PREVOST

WARRANTY BULLETIN

WB16-35A

DATE :	OCTOBER 2016	SECTION :	18 - Body
EXPIRATION:	OCTOBER 2018		
SUBJECT:	LATCH REPLACEMENT ON WHEELCHAIR LIFT ACCESS DOOR

Figure 1: WCL access door

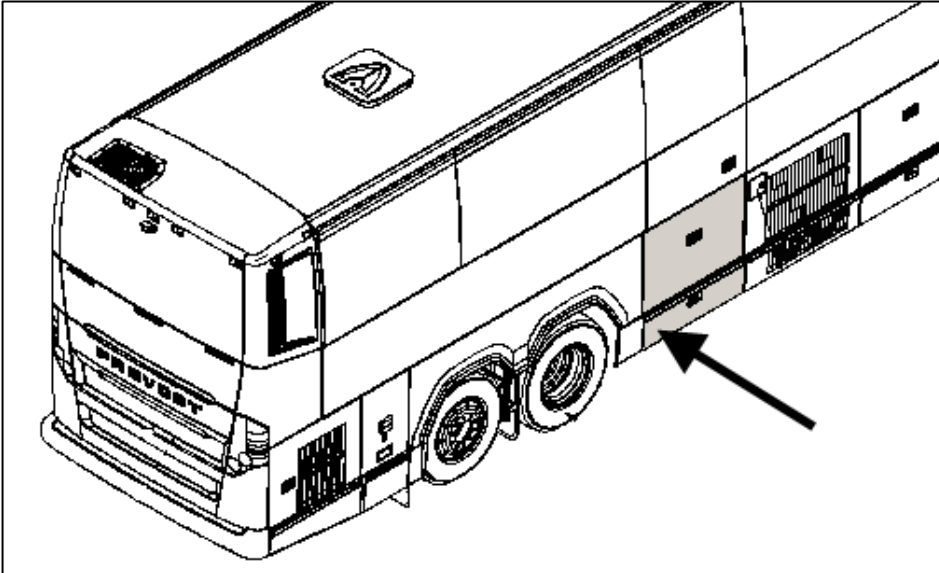
1. On the vehicles, locate the wheelchair lift access door.
2. Open the door. The latch assembly with micro switch is located in the lower left corner.

Figure 2: Control rod clip

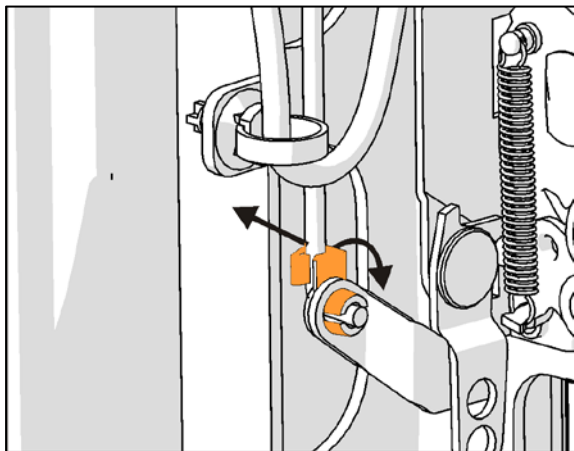
Release clip by rotating it away from rod.
(Figure 2)

Then pull control rod out of clip. Remove clip
from latch lever. Discard clip.

Figure 3

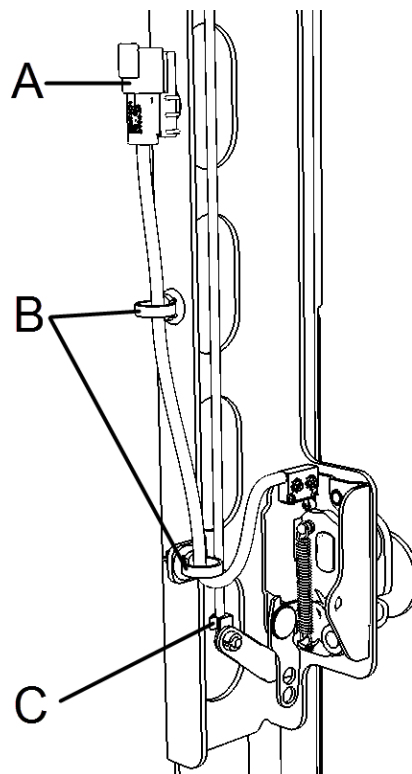
3. Prepare latch for disassembly. (Figure 3)

A Unplug the connector

B Cut the cable ties

C Release clip from control rod.

6. Plug connector to door harness (A, Figure 3)

7. Secure cable with new cable ties.
(B, Figure 3)
